**ENVIRONMENTAL REVIEW COMMITTEE REPORT AND  
ADMINISTRATIVE SITE DEVELOPMENT PLAN REPORT & DECISION**

| <b>Project Name:</b>     | Cedar River Chevron   |
| <b>File Number:</b>      | LUA14-000799, ECF, MOD, SA-A  |

sheet: A2.0  
SCALE AS SHOWN  
DATE: 3/17/2011

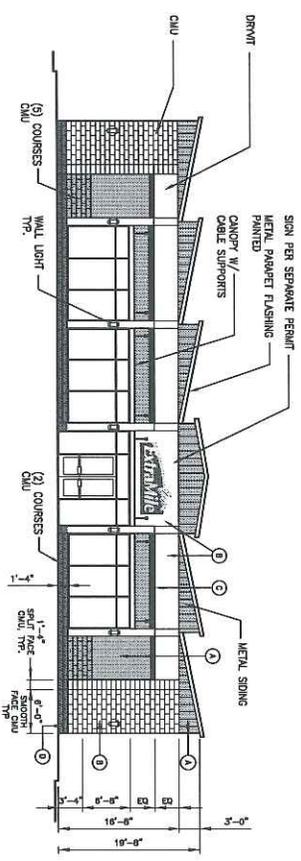
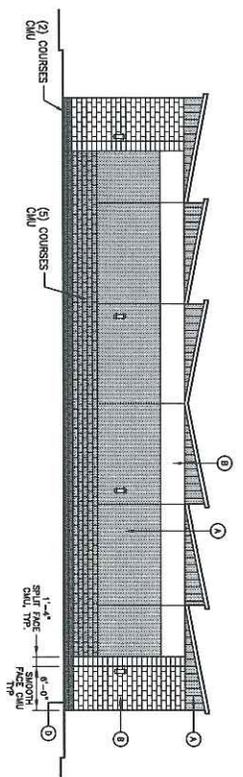
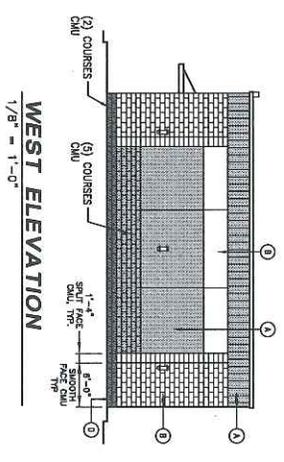
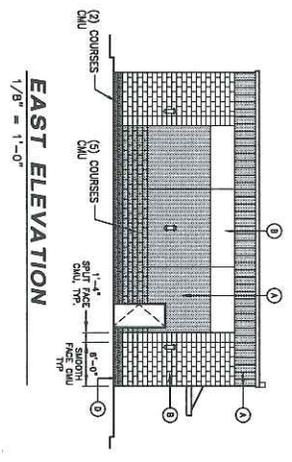
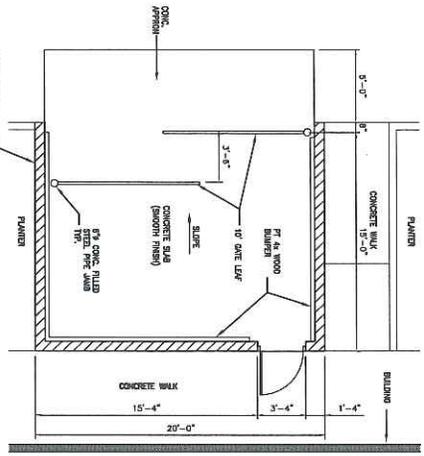
8. The applicant shall revise the following building elevations as follows:
  - a. Convenience store:

- i. Add additional design features, such as windows, awnings, and/or glazing to the south elevation that is consistent with the common thematic elements of the north elevation.

- ii. Add a window to the west elevation that is not blocked by the refuse and recycling facility.
  - iii. Add a metal canopy with cable supports to the west elevation between the split face CMU columns.

- iv. Add an awning or metal canopy with cable supports above the east elevation door.
- b. Carwash:
- i. Add a metal canopy with cable supports to the north and south elevations above the bay doors.

**CARWASH & TRASH ENCLOSURE PLANS & ELEVATIONS**

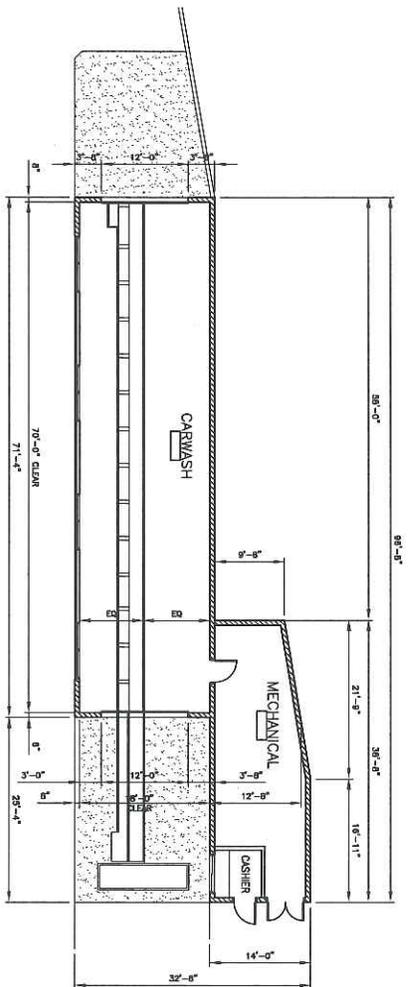
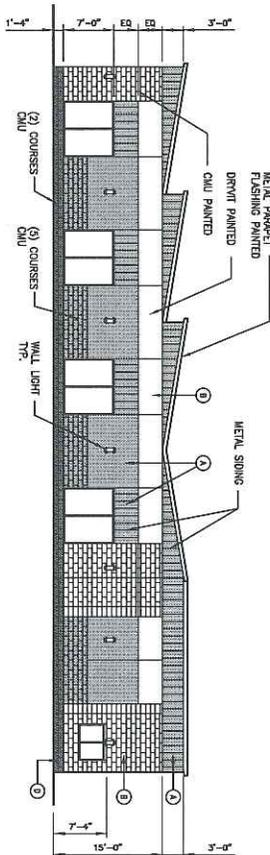
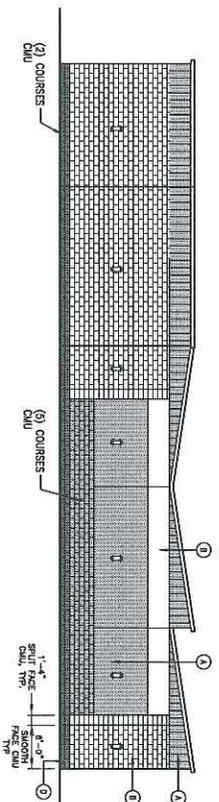
7. The applicant shall revise the refuse and recycling facility to reduce the size from 300 SF to no greater than 144 SF in area and no less than 126 SF, while maintaining a gate opening of at least 12 feet wide for haulers. The colors shall be modified to match the convenience store colors by providing two (2) courses of CMU in mocha color followed by nine (9) courses of CMU in café au lait color. The roof color shall be nutmeg. The proposed revisions to refuse and recycling facility shall be submitted with the building permit application for review and approval by the Development of Community & Economic Development, Planning Division project manager.

- ii. Add an awning or metal canopy with cable supports above the four west elevation windows.
  - iii. Add a window treatment to the four windows on the west elevation.

- c. Mechanical:
- i. Add a metal canopy with cable supports to the south elevation above the two (2) entrances.
  - ii. Add a window treatment to the cashier's window on the west elevation.

GAS CANOPY  
PLANS, ELEVATIONS, DETAILS

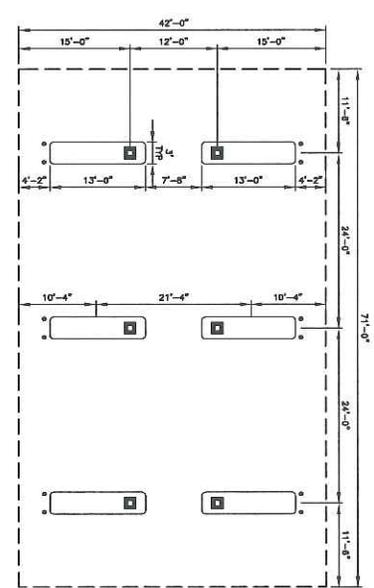
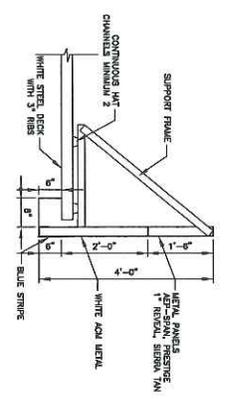
- ii. The CMU cladding around the 10" square steel columns shall be increased from 4' in height to at least 7'-4" in height.
  - iii. The colors shall be modified to match the convenience store colors by providing two (2) courses of CMU in mocha color followed by nine (9) courses of CMU in café au lait color.
